SIB 54 04 17

CREAKING OR RATTLING NOISE FROM SUNROOF AREA

This Service Information Bulletin (Revision 4) replaces SI B54 04 17 **dated May 2018**.

E-Series	Model Description
G12	7 Series Sedan

REPAIR INSTRUCTIONS FOR G12 SUNROOF NOISE

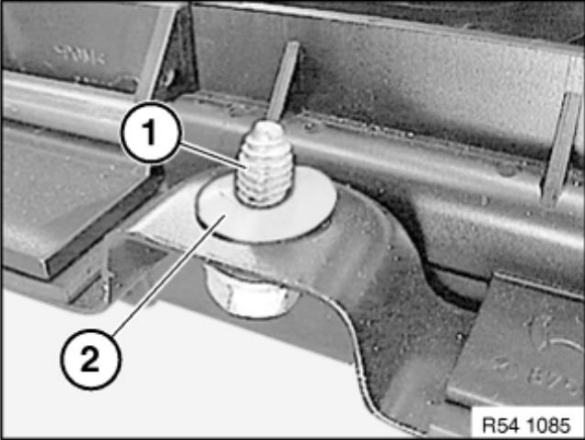
<ol style="list-style-type: none"> 1. Remove the rear sunroof glass panel following repair instructions REP 54 13 250 “Removing and installing/replacing rear glass slide/tilt sunroof panel”. The front glass slide/tilt sunroof will be removed at the same time.
	<ol style="list-style-type: none"> 2. With both glass panels removed from the vehicle, reinforce the threaded bushings by completing the following steps. <ol style="list-style-type: none"> A. Clean the surface area around each threaded bushing with R2 cleaner. Allow to air dry for 2 minutes. B. Clean the area around each threaded bushing with R1 cleaner. Allow to air dry for 2 minutes.

<p>C. Use cartridge gun 83 19 2 149 522 to apply K5a body adhesive around the side of each bushing as shown.</p> <p> Note: Apply adhesive on all of the threaded bushings on the roof for the front and rear glass panels.</p>
	<p> Note: Keep all adhesive off the flat surface of the bushing.</p>
	<p>D. Heat the applied adhesive with a heat gun to an approximate temperature of 175 to 212 degree F (80-100° C). Check the temperature with an infra-red thermometer.</p> <p>E. Apply another layer of adhesive to the side of the bushing repeating Steps 2C and 2D, above.</p> <p>F. Allow the adhesive to cure for at least 12 hours.</p>

<p>3. Reinstall the rear glass sunroof panel, following repair instructions. The original screws will be reused.</p> <p> Note: Tighten the rear glass panel mounting screws exactly to 10Nm using a torque wrench. Coat the screw threads with medium-tight thread locking adhesive (Loctite 243) (BMW part # 83 19 2 210 339)</p>
	<p>4. Reinstall the front glass unit into the vehicle, using new screws (1). Be sure to install plastic washers (2) between the sunroof cassette and the threaded bushing.</p>

5. Coat the front screw threads with medium-tight thread locking adhesive (Loctite 243)

Note: Tighten screws, with a torque wrench, to **exactly 10 Nm**.
